Urgent Field Safety Notice
Programmer Software Update
Supporting the Micra™ Transcatheter Pacing System

Model
2090 CareLink™ Programmer
29901 Encore™ Programmer
CareLink Network Application Software 2491

January 2019

Medtronic reference: FA856

Image 1

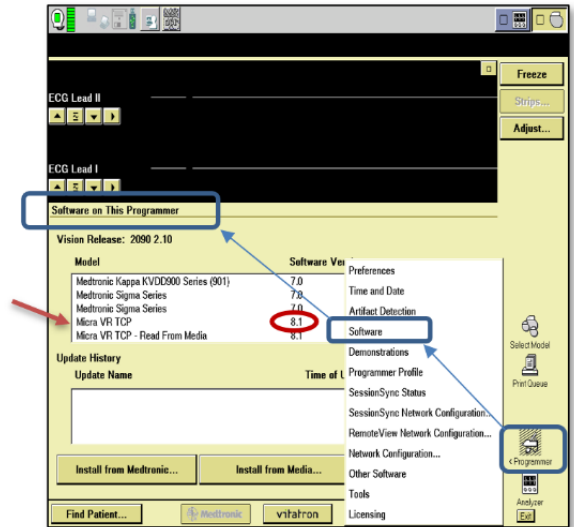
Software Installation History Screen

Correct software: Micra VR TCP version 8.1 (or higher)

From the Programmer start-up screen CANCEL out of the Find Patient window and Select the Programmer icon along the right-hand side of the programmer display:

- Select Software (see image 1)
- Scroll through the list of available Software Models in the top selection box until you locate the Micra selection
- Verify the Software Micra VR TCP Version is 8.1
